UNITED STATES PATENT AND TRADEMARK OFFICE

APPLICATION NO.	FILING DATE	FIRST NAMED INVENTOR	ATTORNEY DOCKET NO.	CONFIRMATION NO.
10/695,160	10/29/2003	Howard E. Rhodes	M4065.0939/P939	7143
24998	7590	10/12/2005	EXAMINER	
DICKSTEIN SHAPIRO MORIN & OSHINSKY LLP				HO, TU TU V
2101 L Street, NW				ART UNIT
Washington, DC 20037				PAPER NUMBER
				2818

Office Action Summary	Application No.	Applicant(s)	
	10/695,160	RHODES, HOWARD E.	
	Examiner Tu-Tu Ho	Art Unit 2818

DETAILED ACTION

Figure 4

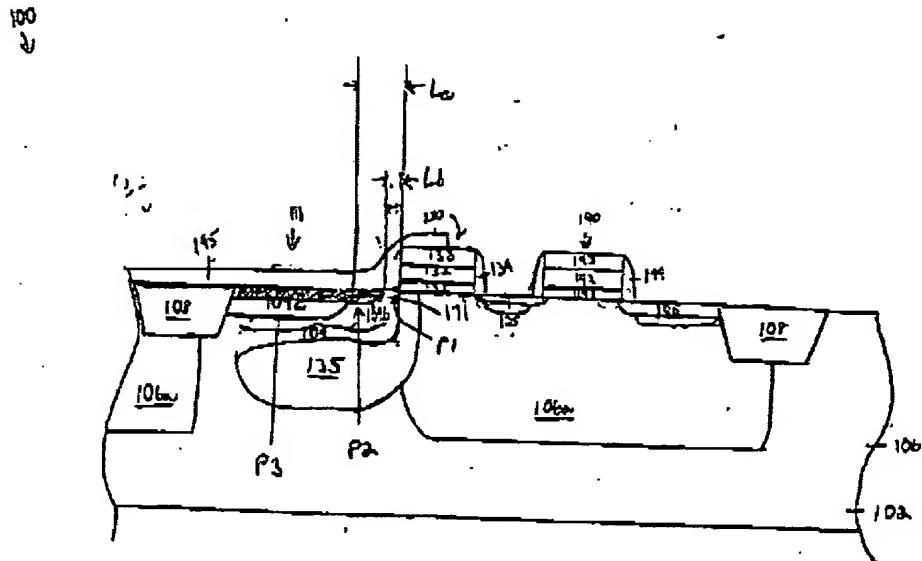
4. New corrected drawings in compliance with 37 CFR 1.121(d) are required in this application because they are not legible, for example Fig. 4, reprinted below or next page. Applicant is advised to employ the services of a competent patent draftsperson outside the Office, as the U.S. Patent and Trademark Office no longer prepares new drawings. The corrected drawings are required in reply to the Office action to avoid abandonment of the application. The requirement for corrected drawings will not be held in abeyance.

FIG. 19

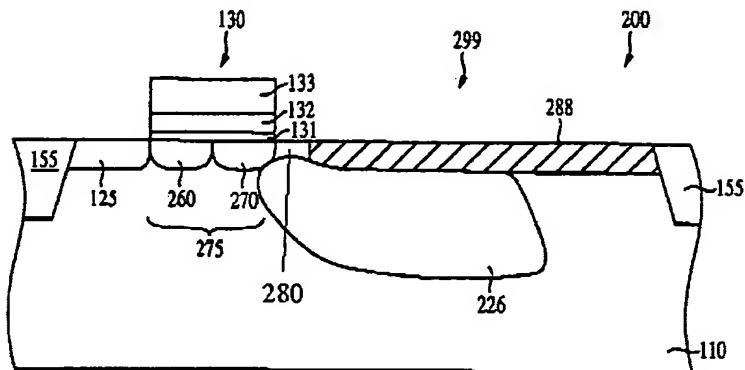
The '799 reference discloses in the figures, particularly Fig. 19, and respective portions of the specification a photoconversion device as claimed.

Referring to **claim 30**, the '799 reference discloses a photoconversion device comprising:
a substrate (110, Fig. 19) having a surface;
a first region (170 or 270) doped to a first conductivity type (p, Figs. 7-19, paragraphs [0075] to [0077]) located below the surface of the substrate;
a second region (280, Fig. 19, reference 280 added by the examiner for ease of explanation) adjacent to said first region; and
a third region (126 or 226) doped to a second conductivity type (n, paragraph [0079]) located beneath said first doped region for collecting photogenerated charges (paragraph [0045]).

Note: Numerical Reference 280 added by the examiner for ease of explanation

Referring to **claim 235** and using the same reference characters, citations, and interpretation as detailed above for claim 30 where applicable, the reference discloses a photoconversion device comprising:

a first region (270) doped to a first conductivity type located below the surface of the substrate, said region having a dopant gradient profile;

a separation region (280); and

a second region (226) doped to a second conductivity type located beneath said first doped region and separation region for collecting photogenerated charges
